Application No: 3/2021/0660 AND 3/2021/0661

Location: BOWLAND SECTION AND MARL HILL SECTION. WORKS AT VARIOUS LOCATIONS.

Proposal: PROPOSED WORKS FOR AND USE OF REPLACEMENT SECTION OF AQUEDUCT, INCLUDING EARTHWORKS AND ANCILLARY INFRASTRUCTURE INCLUDING: A NEW VALVE HOUSE BUILDING WITHIN FENCED COMPOUND WITH PERMANENT VEHICULAR ACCESS PROVISION. WITH THE INSTALLATION OF A TUNNEL PORTAL AND AN OPEN CUT CONNECTION AREA WITHIN A TEMPORARY CONSTRUCTION COMPOUND, TO INCLUDE SITE ACCESSES, STORAGE AREAS, PLANT AND MACHINERY, AND DRINAGE INFRASTRUCTURE AND A TEMPORARY HAUL ROUTE WITH BRIDGE OVER THE RIVER HODDER. IN ADDITION, A TEMPORARY HAUL ROUTE WITH BRIDGE OVER THE RIVER RIBBLE (AS ONE OF TWO OPTIONS FOR VEHICULAR ACCESS TO THE TEMPORARY CONSTRUCTION COMPOUND); A SERIES OF LOCAL HIGHWAY WORKS TOGETHER WITH A TEMPORARY SATELLITE PARK AND RIDE FACILITY AND A VEHICLE MARSHALLING AREA.

Summary

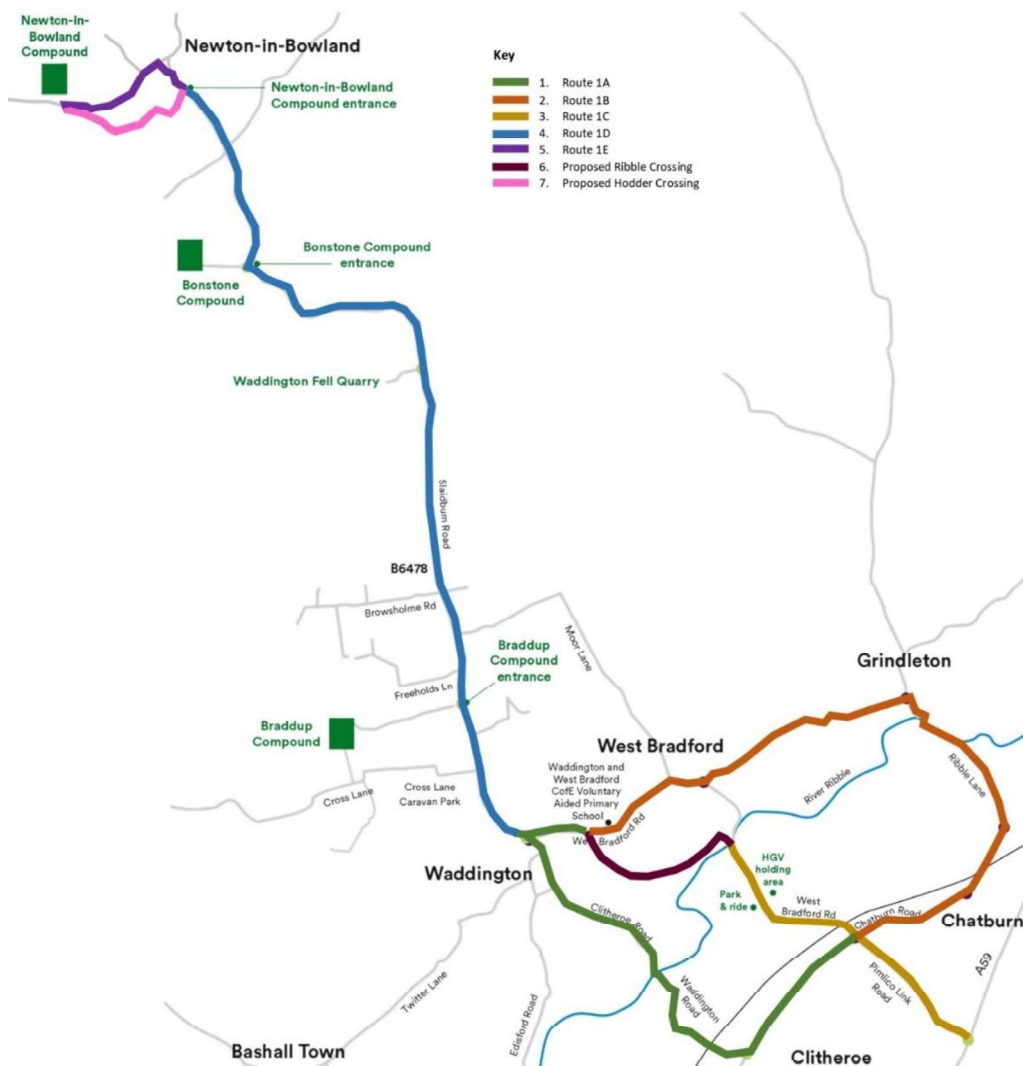
Route 1A (for vehicles under 3.5m high) to access the northern end of the proposed Ribble Crossing

Route 1B (for vehicles over 3.5m high) to access the northern end of the proposed Ribble Crossing

Route 1C to access the southern end of the proposed Ribble Crossing.

Route 1D extension to Routes 1A and 1B to access the B6478 for the eastern side of the proposed Hodder Crossing.

Route 1E is proposed to access the western side of the proposed Hodder Crossing.

Note: the CTMP will need to identify how the risk of vehicles not using the current route and how this will be managed (i.e., tractors being interchangeable with trailers).
